U.S. Department
of Transportation
**Federal Highway
Administration**

In Reply Refer To:
HSSI/WZ-25A

This is in response to your October 7 correspondence requesting the Federal Highway Administration's (FHWA) acceptance of your company's Model FS2000W portable sign stand as a crashworthy traffic control device for use in work zones and elsewhere on the National Highway System (NHS). Accompanying your letter was the FHWA Office of Safety Design form explaining the change from a coiled spring (as in the Model UF2000W stand accepted in WZ-25) to a flat one. You requested that we find this device acceptable for use on the NHS under the provisions of National Cooperative Highway Research Program Report 350 "Recommended Procedures for the Safety Performance Evaluation of Highway Features."

This inquiry is in regards to a modified version of the previously accepted UF2000W sign stand (HAS-1/WZ-25). The new version of this stand FS2000W replaces the coiled spring with a flat steel spring. The stand footprint is the same while the top of the sign bracket is actually lower. The stand specifications may be found in Table #1 below and in the attached drawings.

#2d - UF2000W / FS2000W Side by Side Comparison

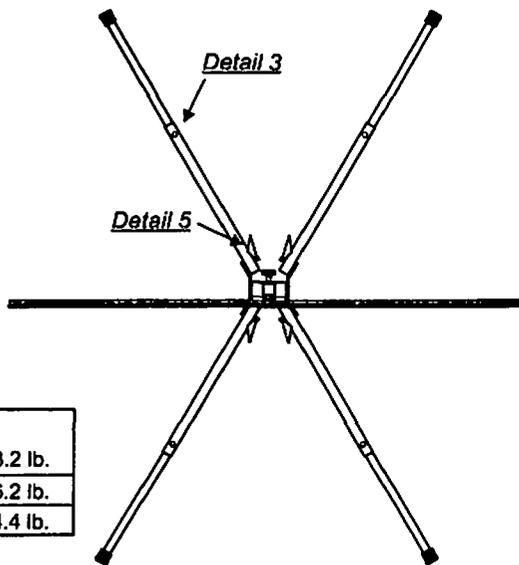
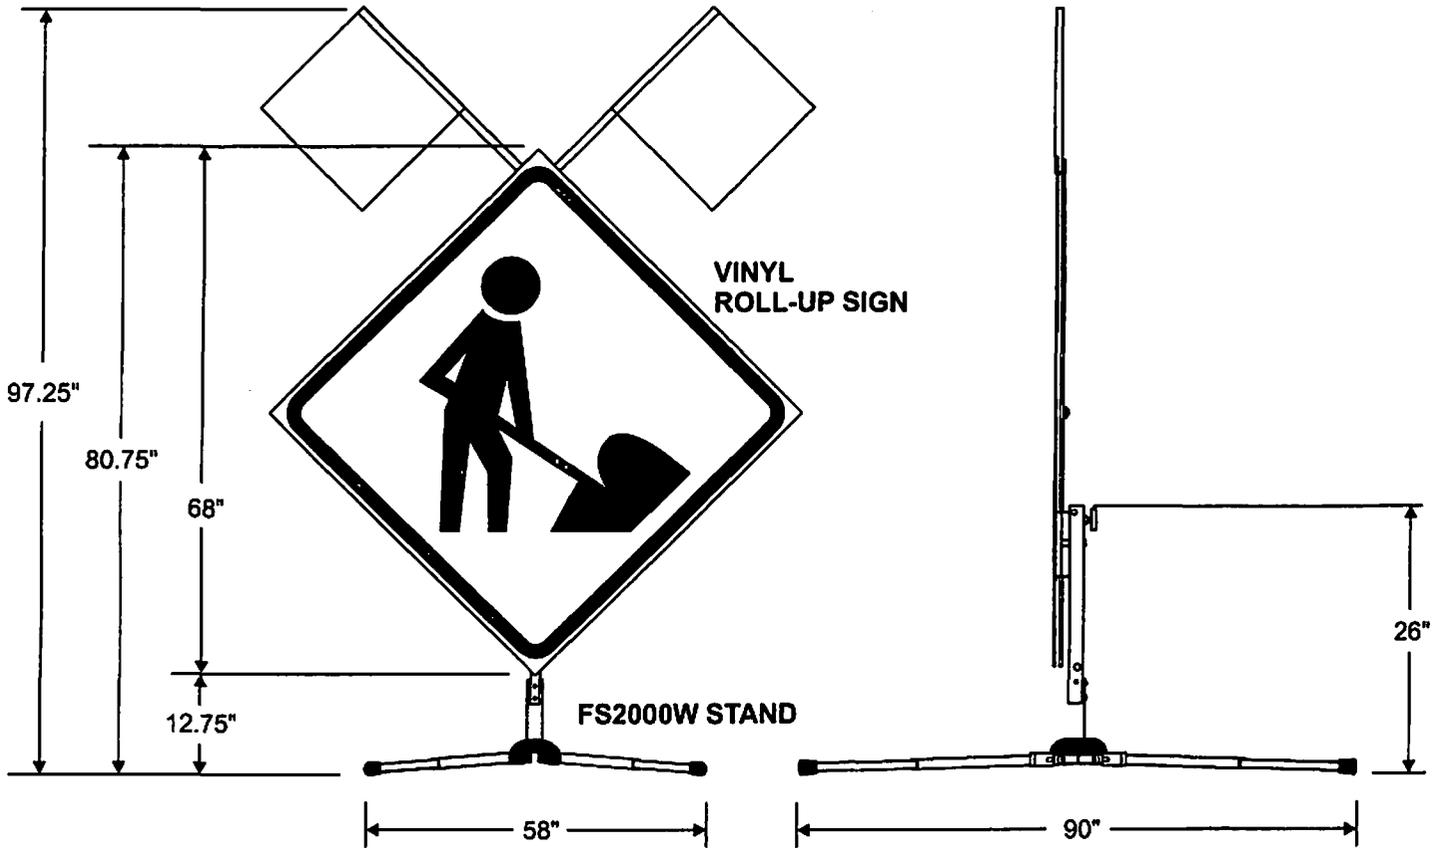
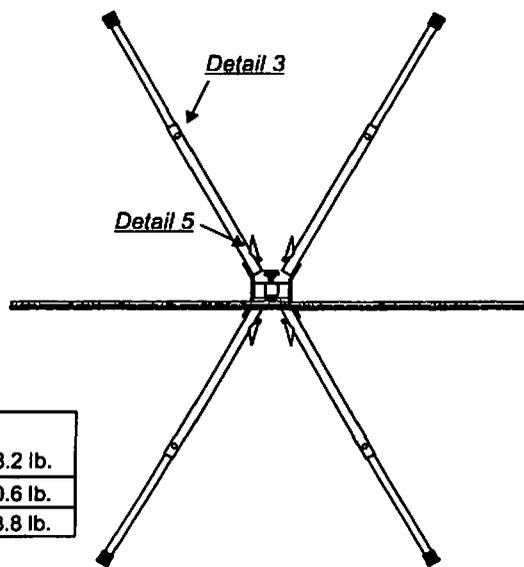
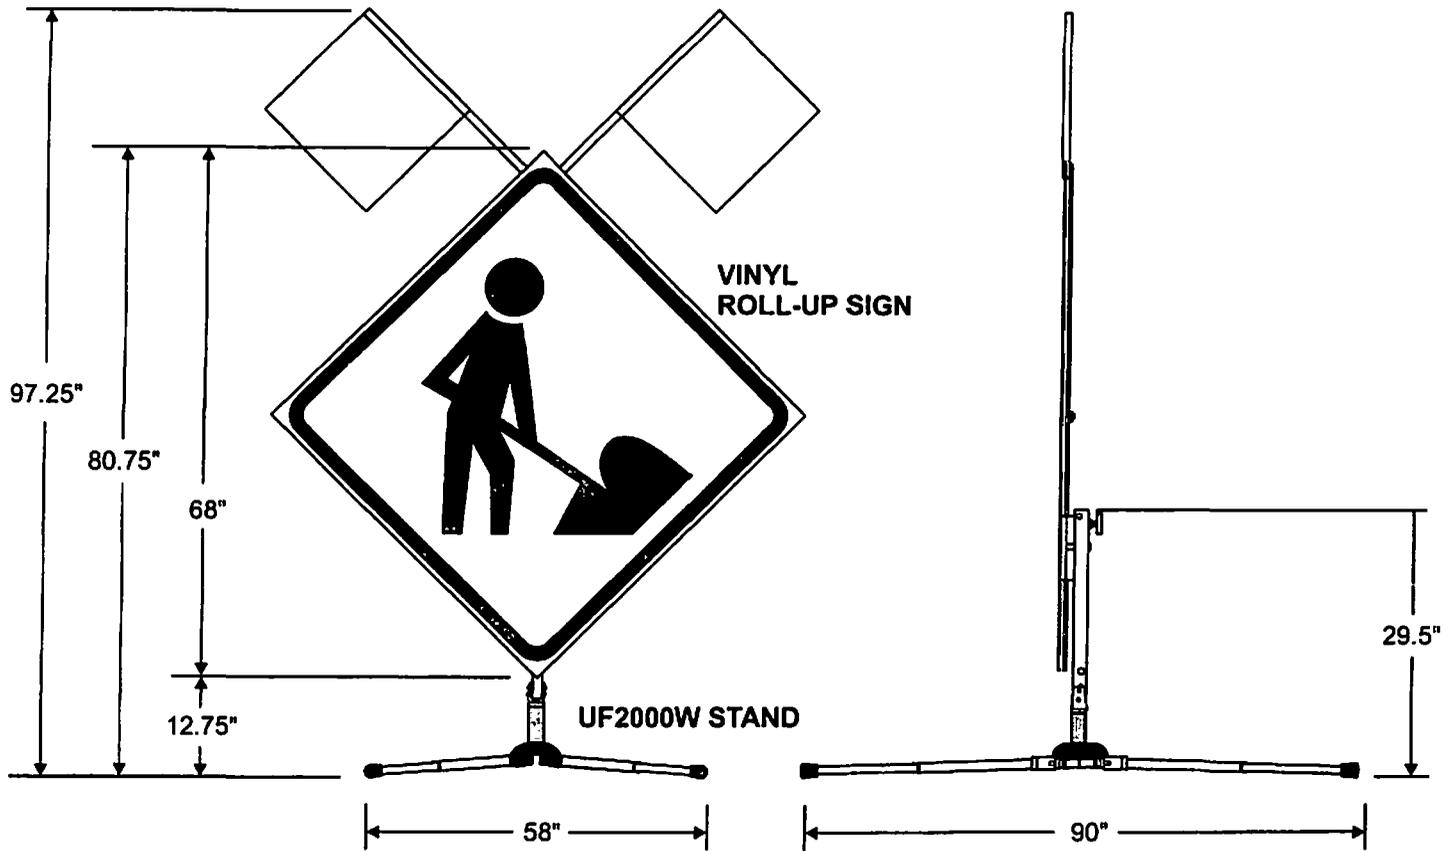
Based on the enclosed information and previous test data, we are seeking acceptance of sign stand FS2000W. We believe this to be a reasonable request because the design differences all occur below the height of the vehicle bumper. As such, we contend that they will have no effect on the windshield impact data.
